STAFF REPORT  
(One-Step Final Plat)

CASE NUMBER: S/D 99-38 - WINTER FARM ADDITION

LOCATION: West side of 263<sup>rd</sup> St. West, North of 69th St. North

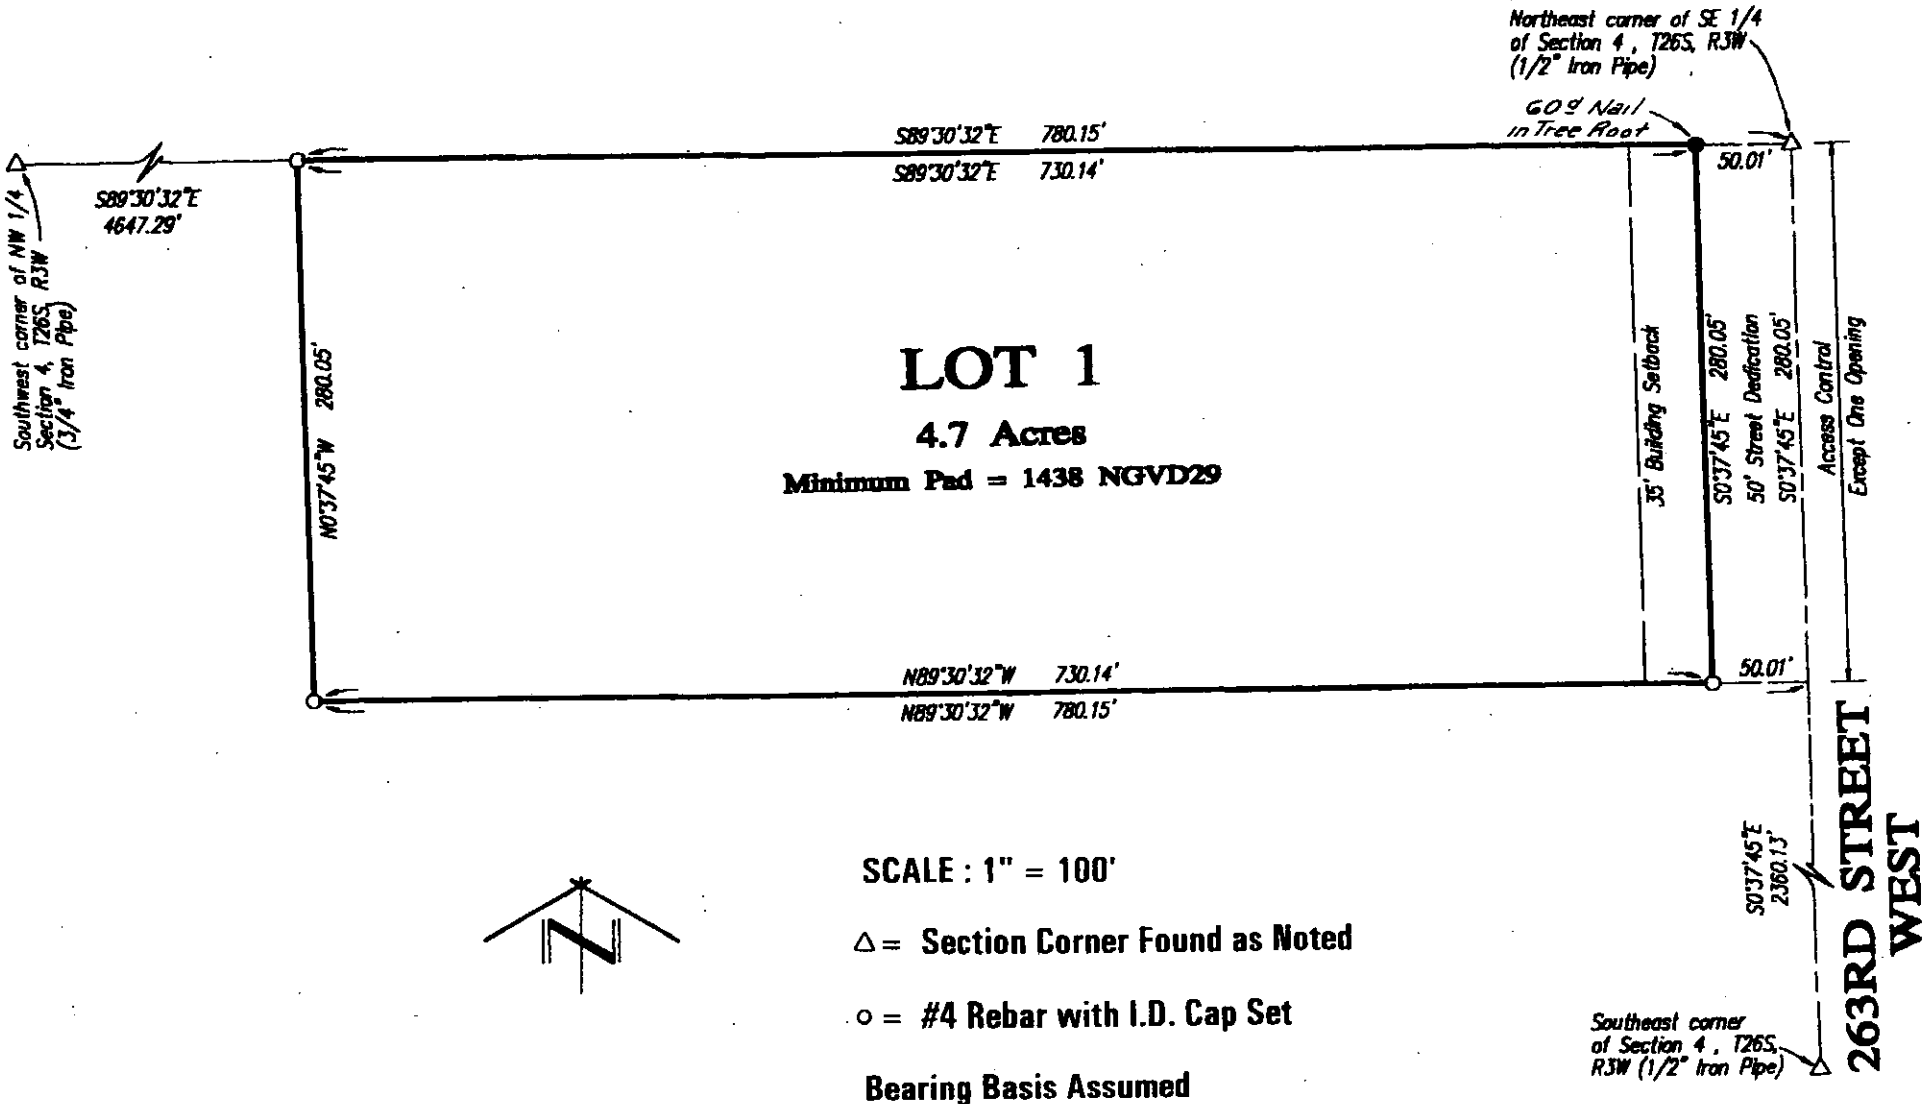
- C. County Engineering needs to comment on the status of the applicant's drainage plan and the accuracy of the floodway reserve boundaries.
- D. Bill Hancock is the only signature required in the County Commissioners signature block.

- E. The 30-ft setback needs to be increased to 35 feet to comply with the required 85-ft setback from the centerline of County roads.
- F. The lot depth to width ratio exceeds the 2.5 to 1 standard and a modification will need to be granted if this plat is approved.
